Model: Model L2a	Date: 9-Sep-04	No.: RH914001b
------------------	----------------	----------------

Subject: Firmware History		Prepared by: T. Shintani	
From: 1st Technical Support Sec. Service Support Dept.			
Classification:	<input type="checkbox"/> Troubleshooting <input type="checkbox"/> Mechanical <input type="checkbox"/> Paper path <input type="checkbox"/> Other (      )	<input type="checkbox"/> Part information <input type="checkbox"/> Electrical <input type="checkbox"/> Transmit/receive	<input checked="" type="checkbox"/> Action required <input type="checkbox"/> Service manual revision <input type="checkbox"/> Retrofit information

Model: Model L2a/b/c		Date: 13-May-09	No.: RH914007
Subject: Sheet Guide Paper (Paper Feed)		Prepared by: Y. Gaman	
From: 1st Tech. Support Sec. Service Support Dept.			
Classification:	<input type="checkbox"/> Troubleshooting <input type="checkbox"/> Mechanical <input type="checkbox"/> Paper path <input type="checkbox"/> Product Safety	<input checked="" type="checkbox"/> Part information <input type="checkbox"/> Electrical <input type="checkbox"/> Transmit/receive <input type="checkbox"/> Other (     )	<input type="checkbox"/> Action required <

## 6.Paper Feed (H916)

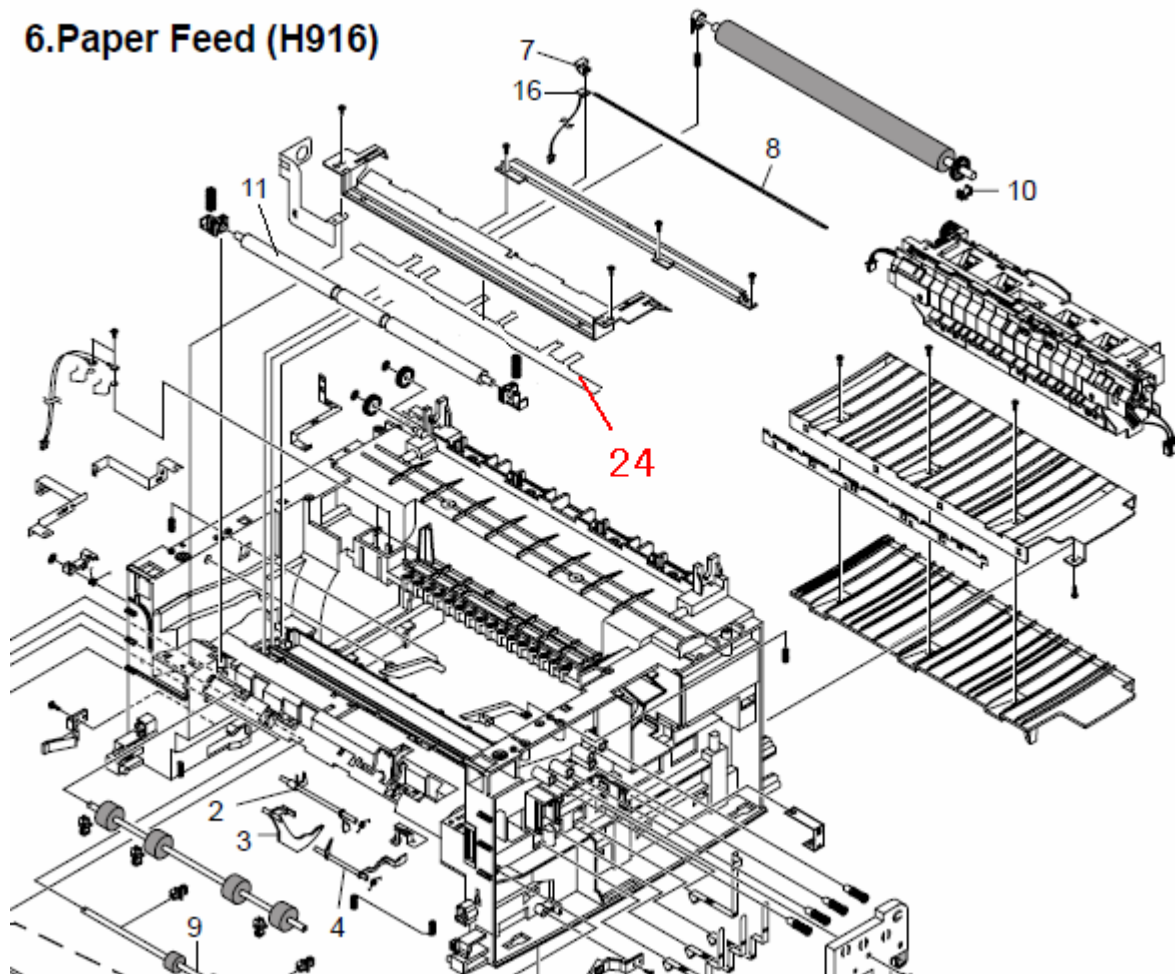
**Change:** This part was added.

**Reason:** Requests from the field.

NEW Part	Description	Q'ty	Int	Page	Index	Note
H9169687	Sheet Guide Paper	1	-	11	24

NEW Part	Description	Q'ty	Int	Page	Index	Note
H9169687	Sheet Guide Paper	1	-	13	24

## 4.Upper Scanner (H916)

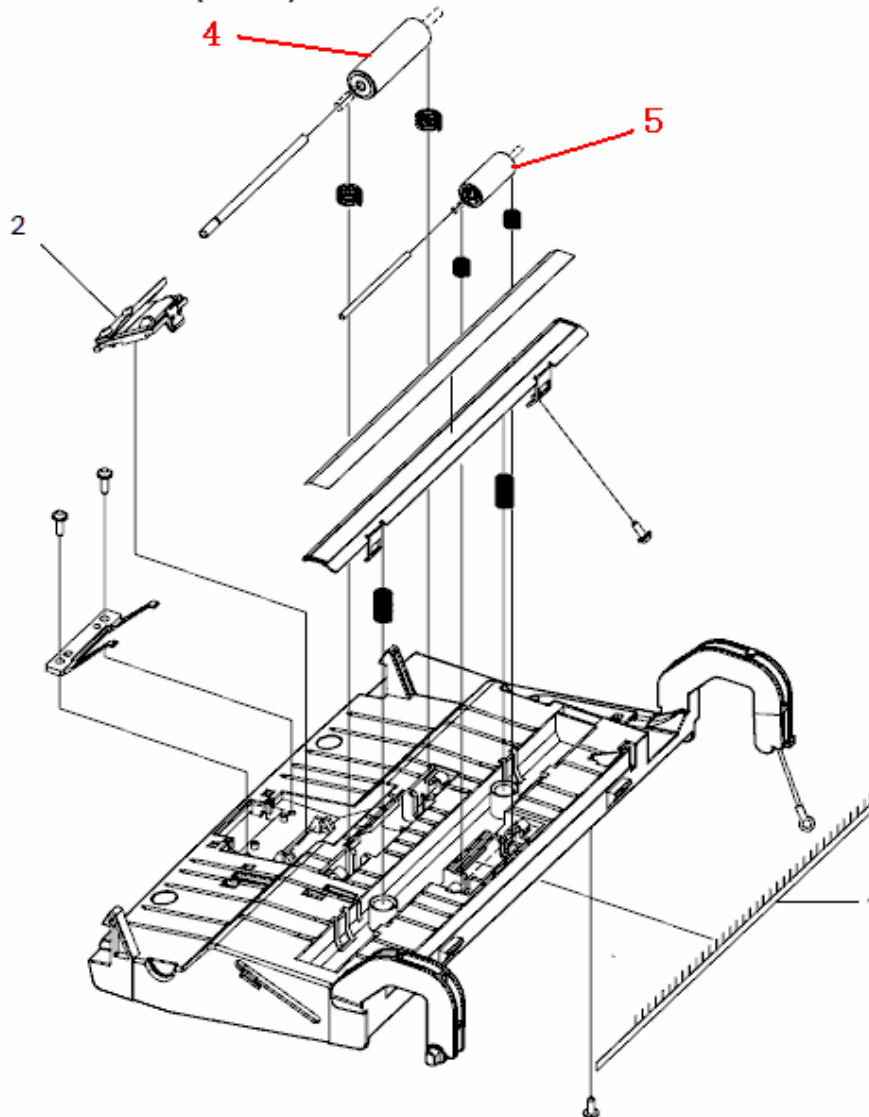
**Change:** This part was added.

**Reason:** Requests from the field.

NEW Part	Description	Q'ty	Int	Page	Index	Note
H9169688	ROLLER IDLE SCAN	1	-	9	4	
G9601197	PINCH ROLLER	1	-	9	5

## Block Diagram for the H916

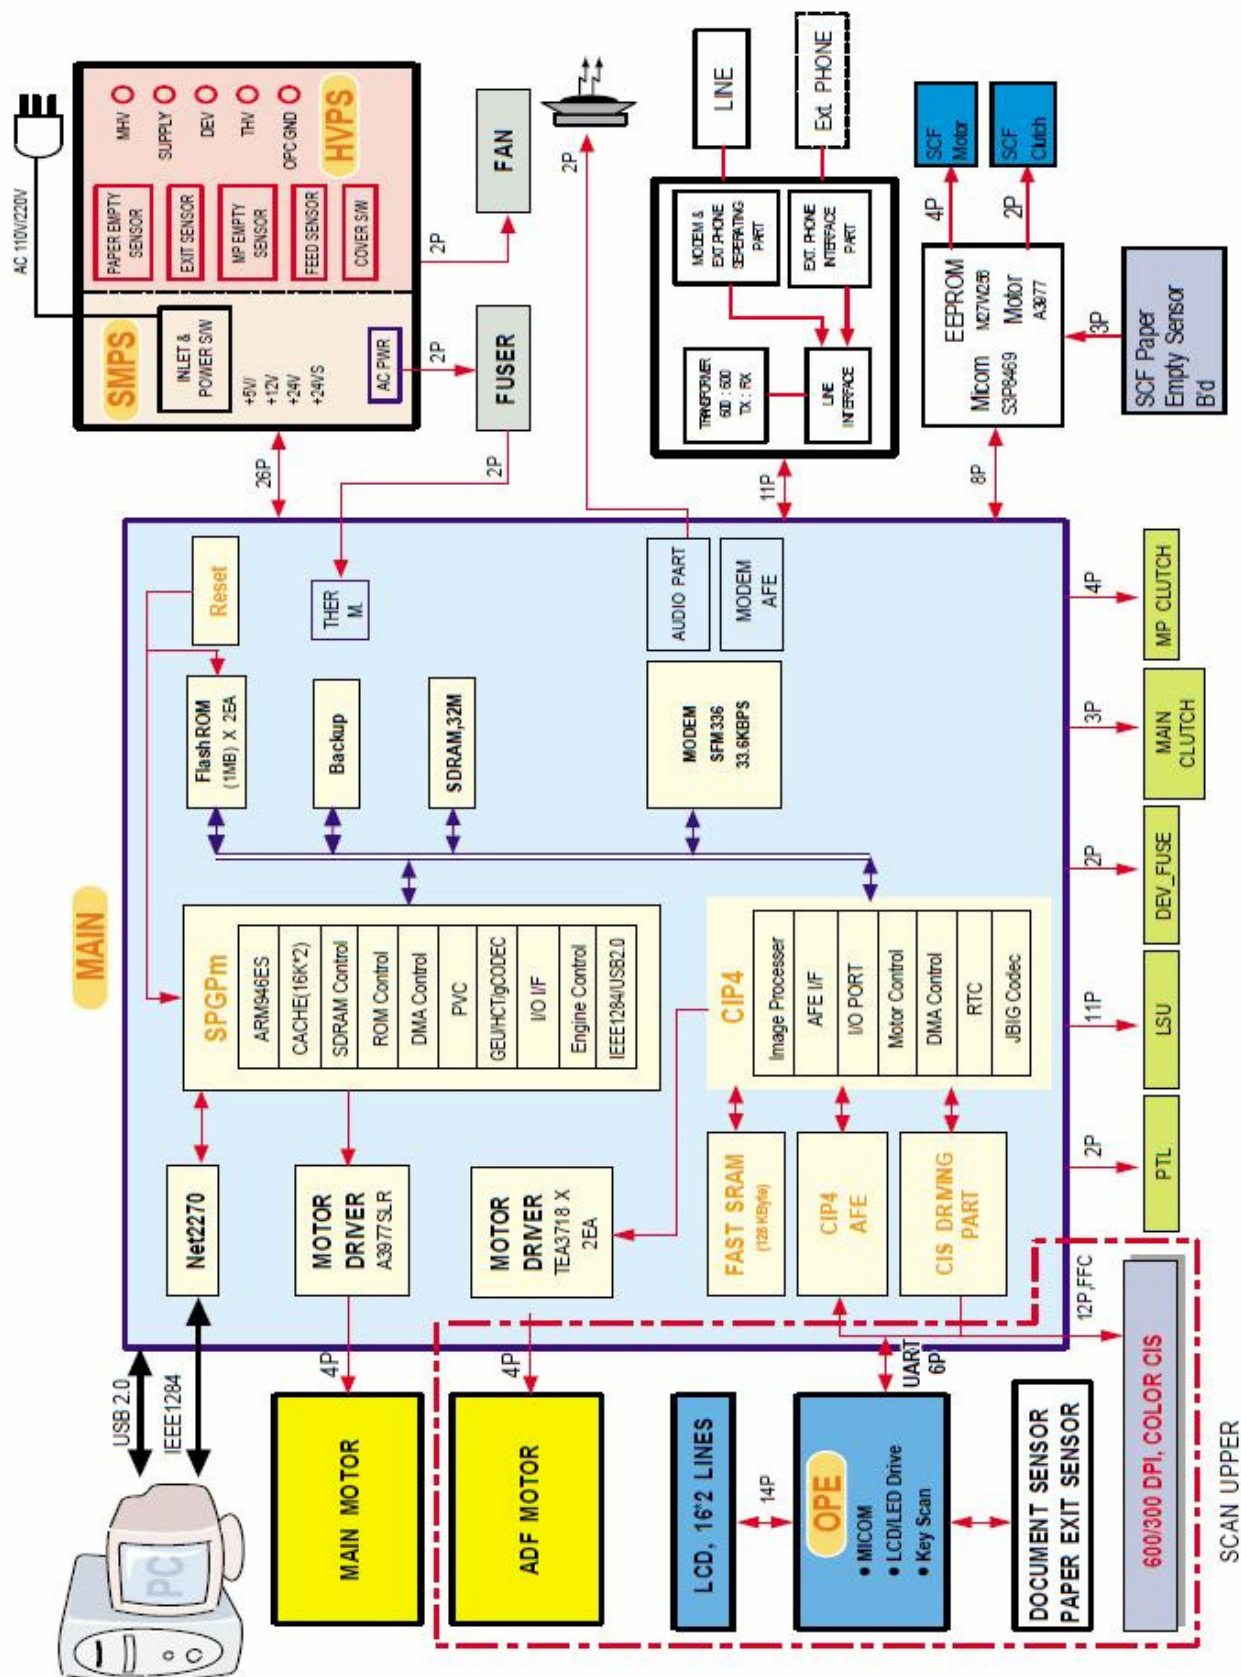
**Add** the block diagram and connection diagram for the H916 to the Appendix (see the next page).

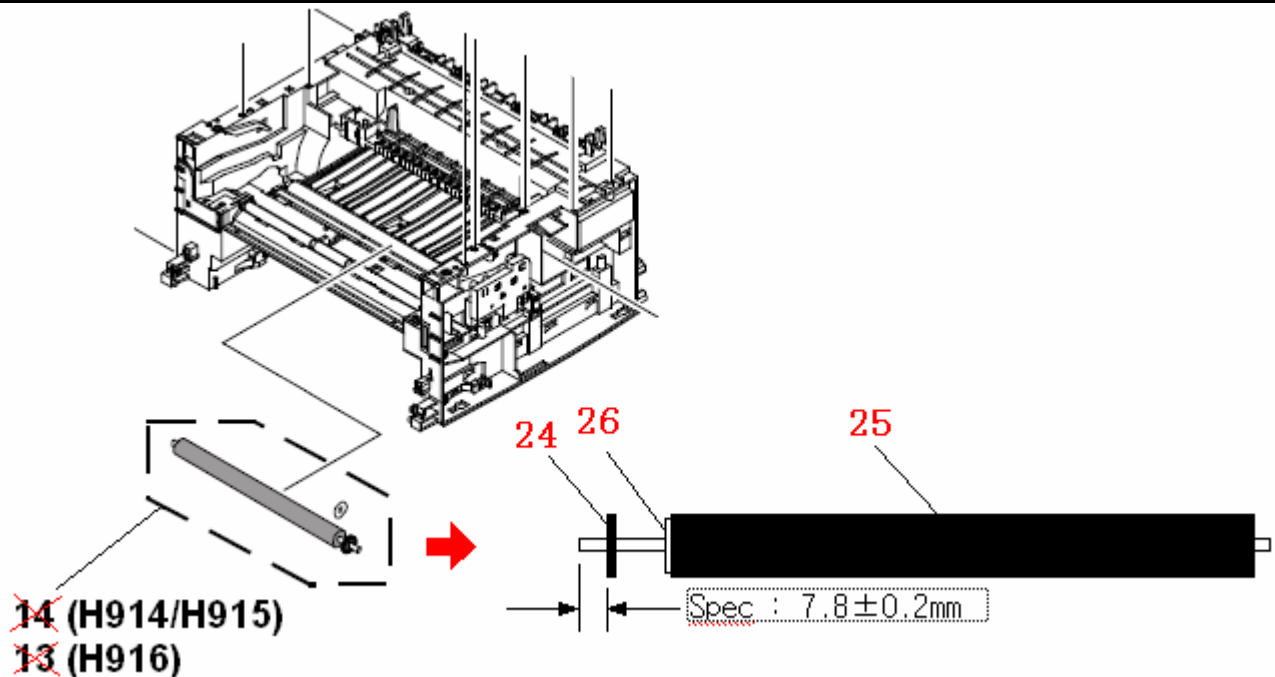
**Change:** P/N B1739513 was divided into three separate parts.

**Reason:** The parts vendor stopped supplying P/N B1739513 as an assembly.

Old Part Number	New Part Number	Description	Q'ty	Int	Page	Index	Note
B1739513	B1739801	GEAR - TRANSFER	1	O/O	3	14→24	
	B1739802	ROLLER - TRANSFER	1			14→25	
	B1739803	SPACER - TRANSFER	1			14→26

Old Part Number	New Part Number	Description	Q'ty	Int	Page	Index	Note
B1739513	B1739801	GEAR - TRANSFER	1	O/O	3	13→24	
	B1739802	ROLLER - TRANSFER	1			13→25	
	B1739803	SPACER - TRANSFER	1			13→26

## 8.Paper Cassette (H914/H915)

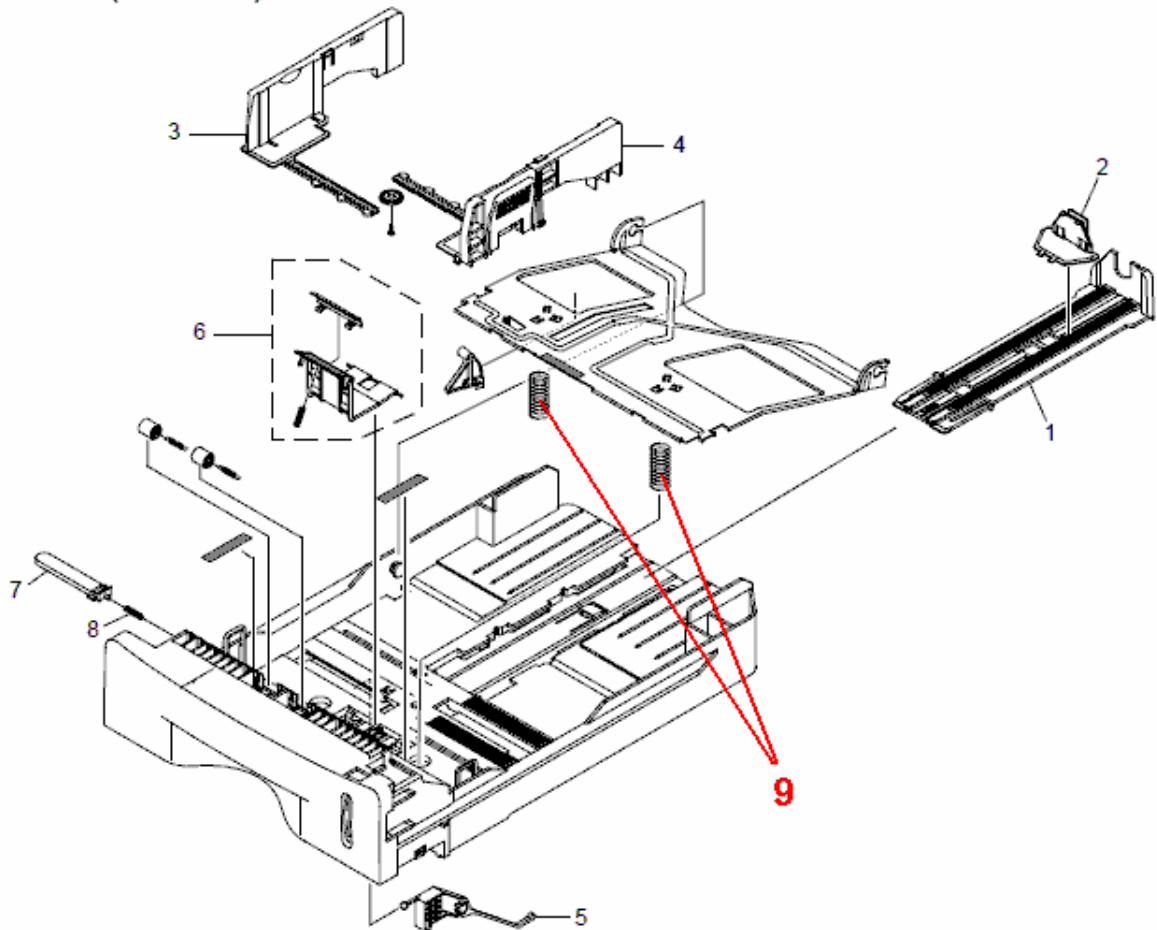
**Change:** This part was added.

**Reason:** Requests from the field.

NEW Part	Description	Q'ty	Int	Page	Index	Note
G9601016	SPRING - CASSETTE	2	-	17	9

## 9.Paper Cassette (H916)

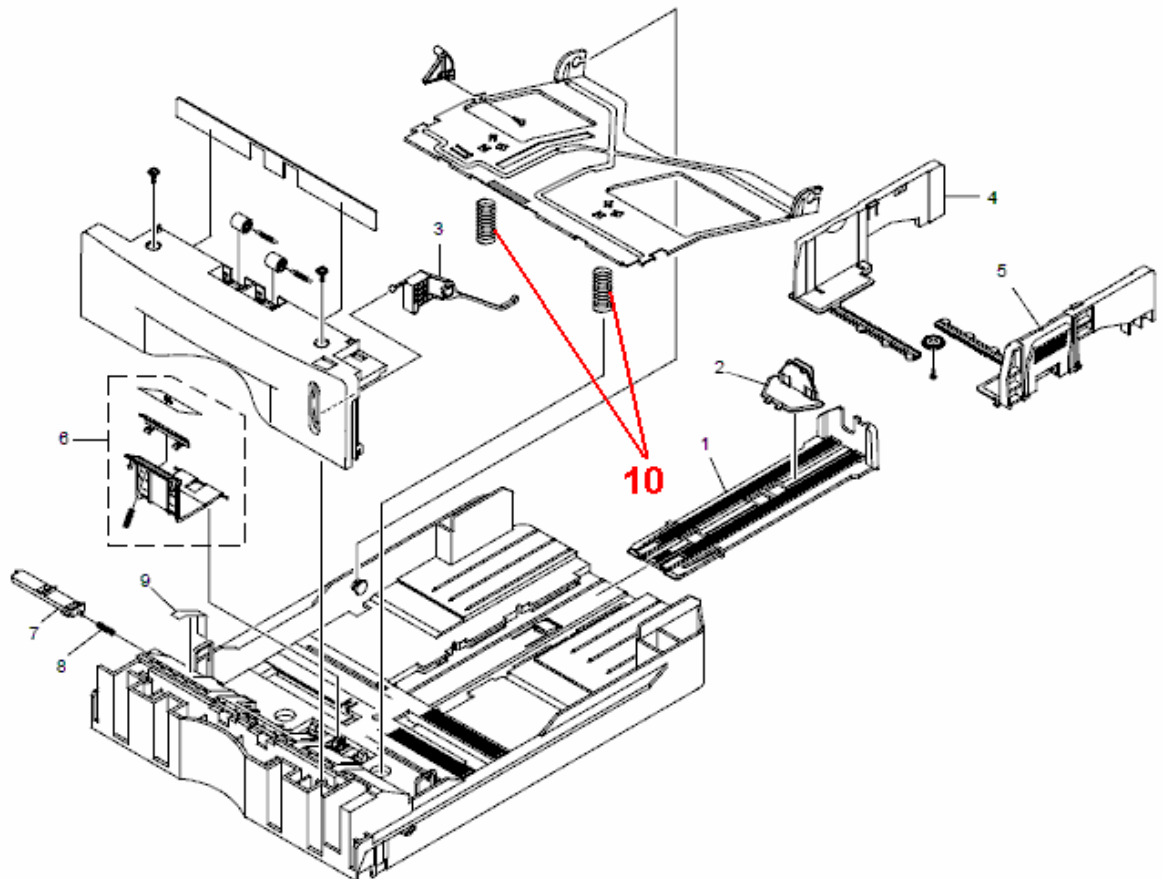
NEW Part	Description	Q'ty	Int	Page	Index	Note
G9601016	SPRING - CASSETTE	2	-	19	10

## 2.Top Cover (H916)

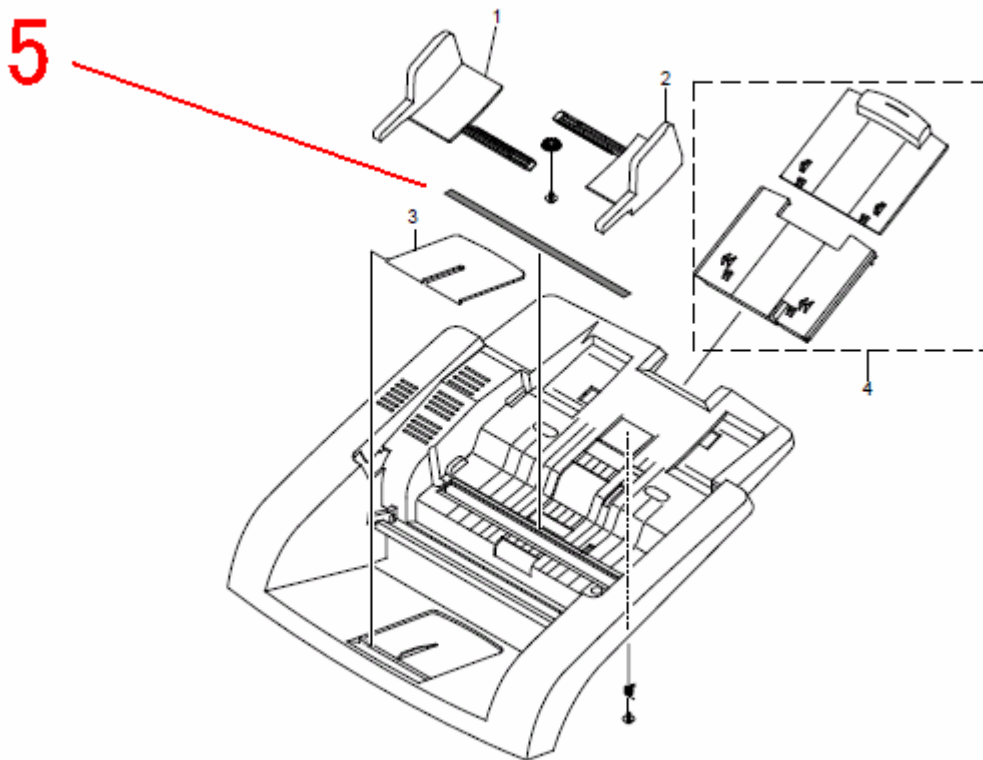
**Change:** This part was added.

**Reason:** Requests from the field.

NEW Part	Description	Q'ty	Int	Page	Index	Note
H9169689	SHEET-CIS	1	-	5	5

## 5.Paper Feed (H914/H915)

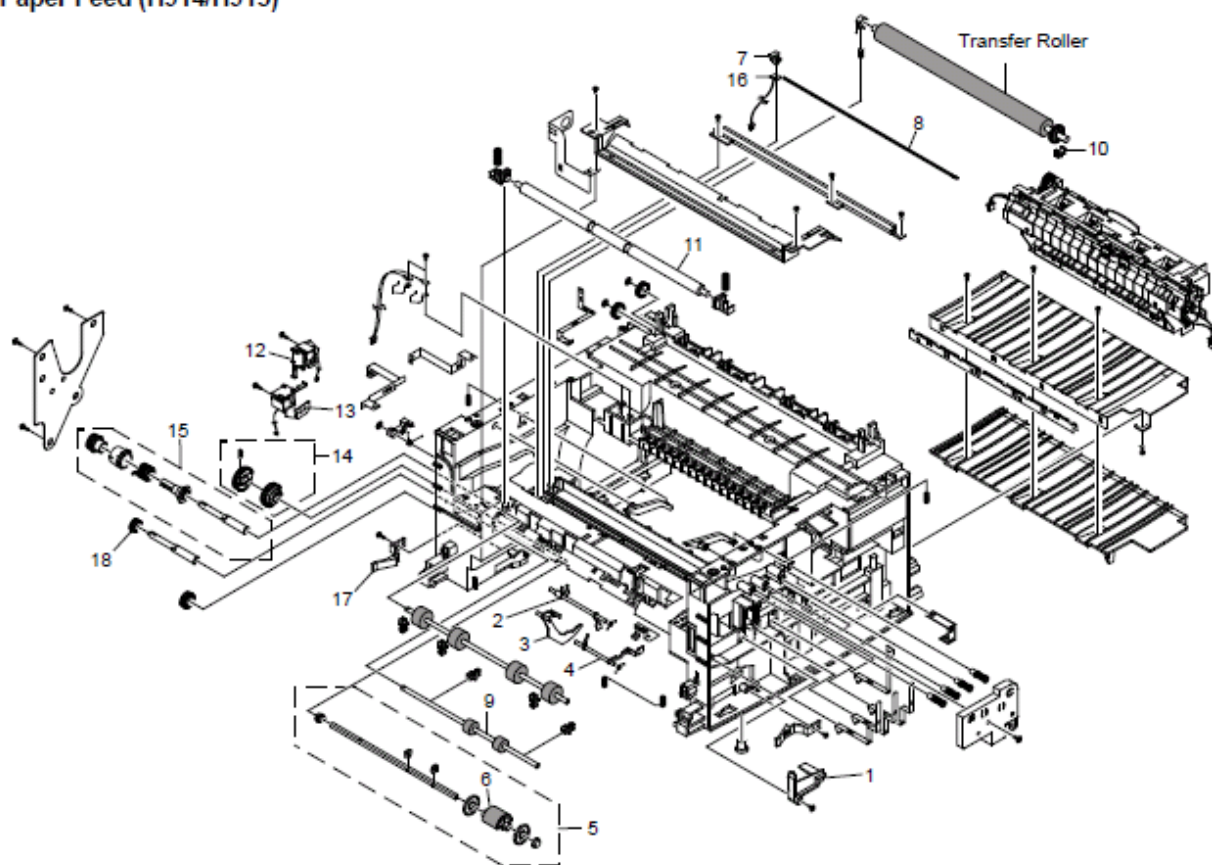
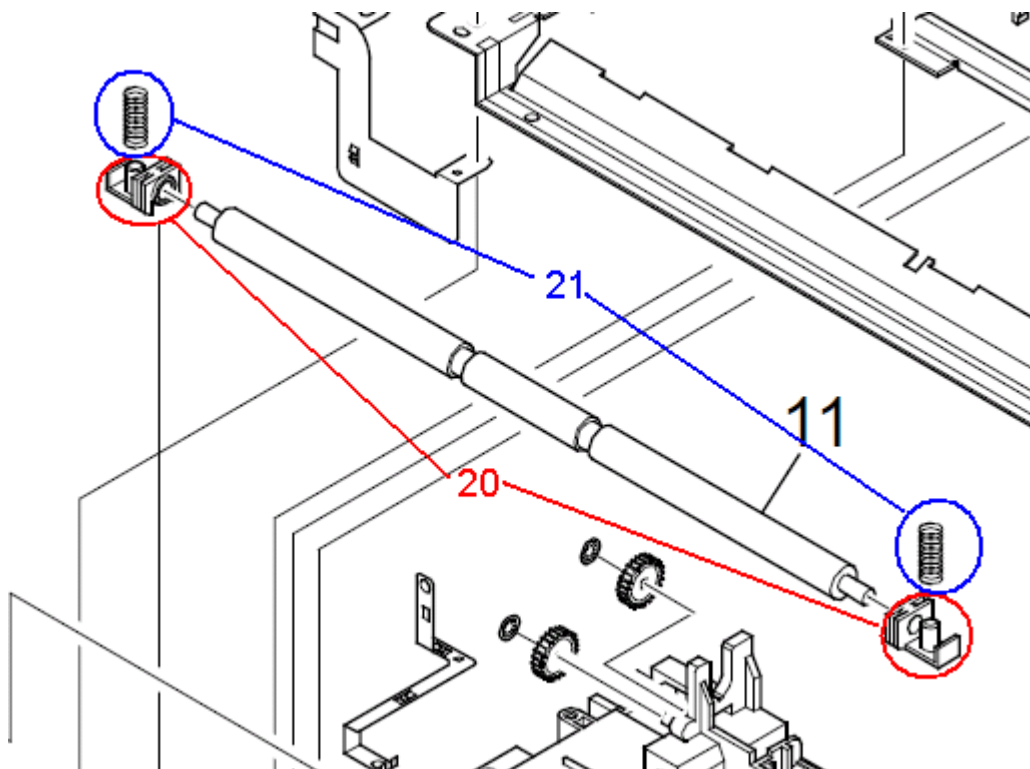
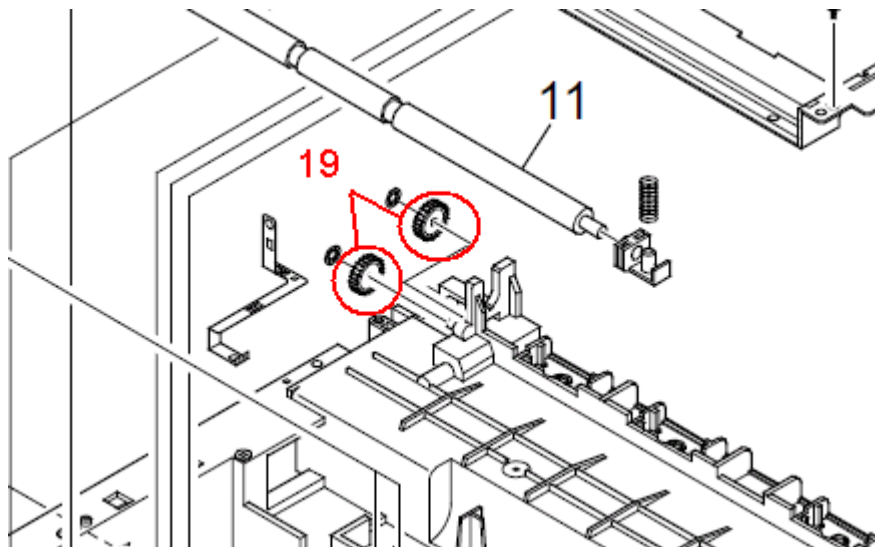
**Change:** These parts were added.

**Reason:** Requests from the field.

New Parts	Description	Q'ty	Int	Page	Index	Note
B1739804	GEAR DRIVE16	2		11	19	
G1449556	BUSHING-IDLE SHAFT	2		11	20	
G9601080	PRESSURE SPRING	2		11	21
